# SERVICE BULLETIN

Service Bulletin No.: DA20-56-1, Rev. 0

Title: Canopy, Side Window Water Drain

Figure 1a.

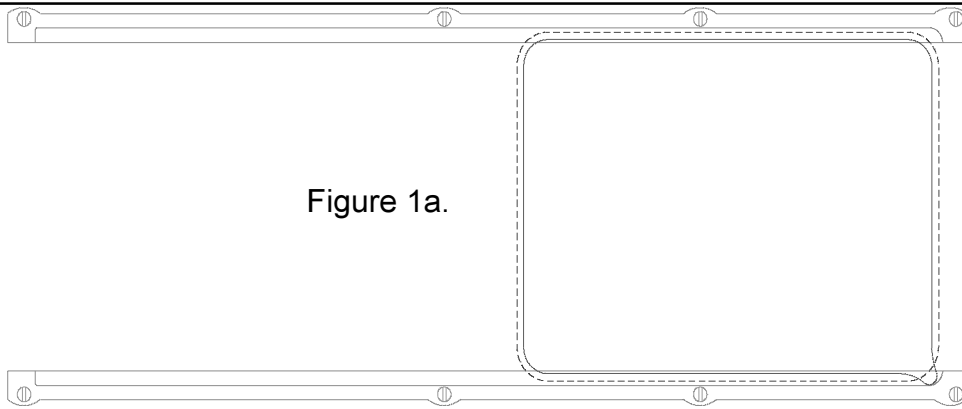
9. **References:** DA 20 Katana Maintenance Manual Doc. No. DA201
10. **Accomplishment Instructions:**
- 10.1 Determine the trough style installed on the aircraft, either Figure 1a or 1b.

Figure 1b.

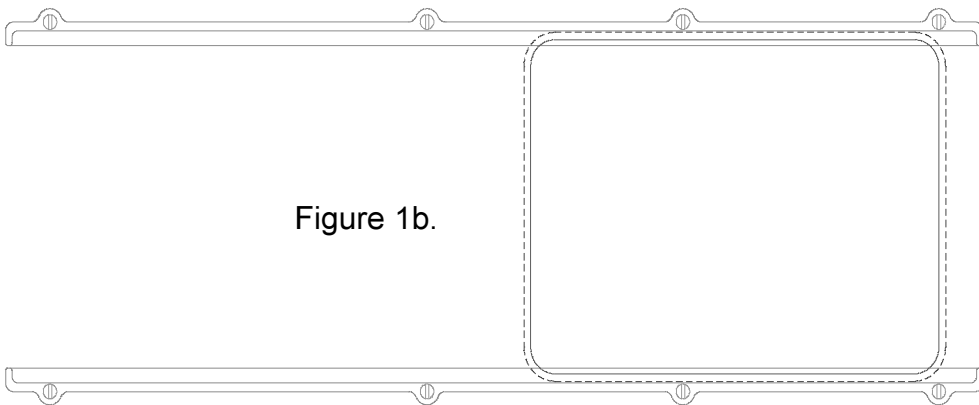
- 10.2 If the style shown in Figure 1b is installed, a 6mm (ref 15/64") drill will need to be dressed as shown in Figure 2a. The hole is to be located as shown in Figure 2b.

Figure 2a.

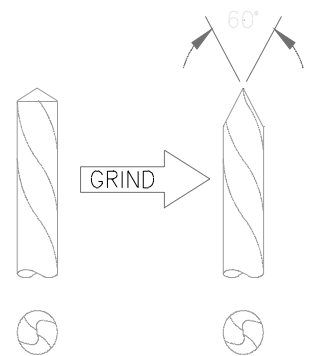
**CAUTION:** It is **very important** to remember that when drilling the acrylic:
    - (a) the drill must be dressed as shown in Figure 3 and,
    - (b) to press lightly all the way through. Let the dressed drill melt/cut its way through the acrylic. Carefully remove any sharp edges with a small round file.

Figure 3.

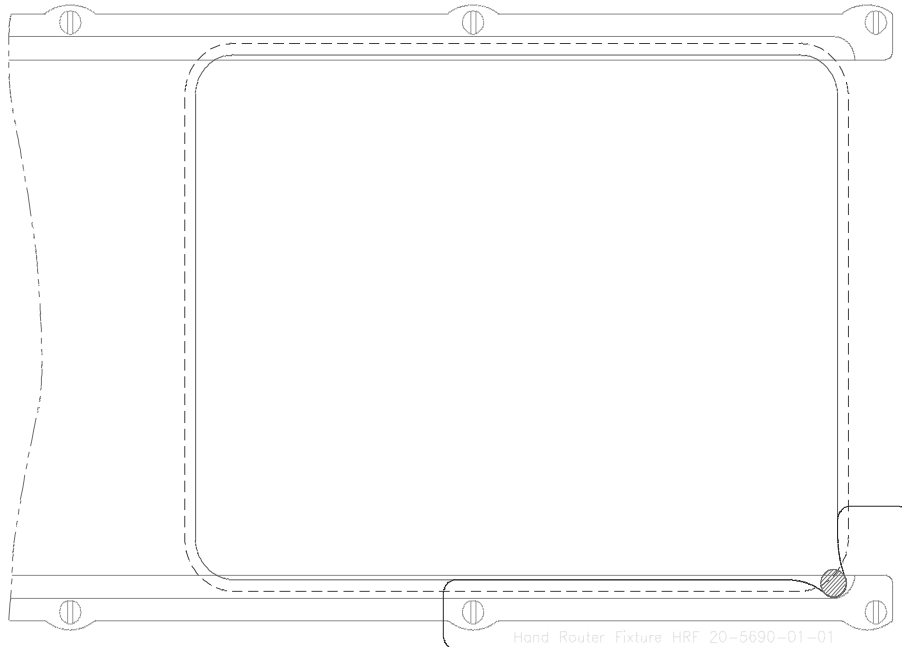
10.3 If the window style shown in Figure 1a then the modification is as per Figure 3. A template of the router fixture is depicted in Figure 9, page 6 which locates on the two forward trough screws. Fashion a routing template based on the attached drawing. Locate the the template on the two forward screws and using a 1/16" or 1/8" tapered router bit route the canopy as shown in Figure 3 using the template as a guide. Carefully remove any sharp edges with a small round file.

Figure 6.

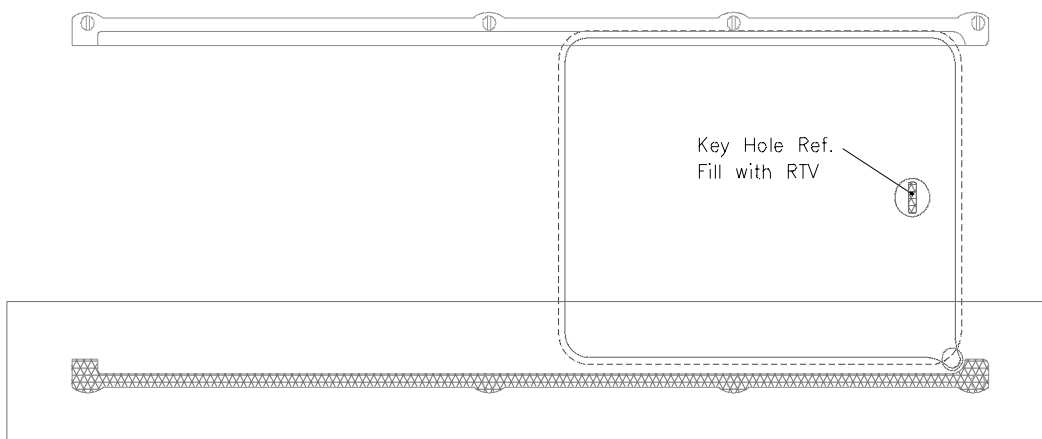
- 10.6 Apply a bead of RTV 108 to the exposed likeness of the trough (Figure 6) on the canopy. Fill the locking mechanism hole in the knob of the sliding window. Use only as much as required to keep the next steps from being messy.
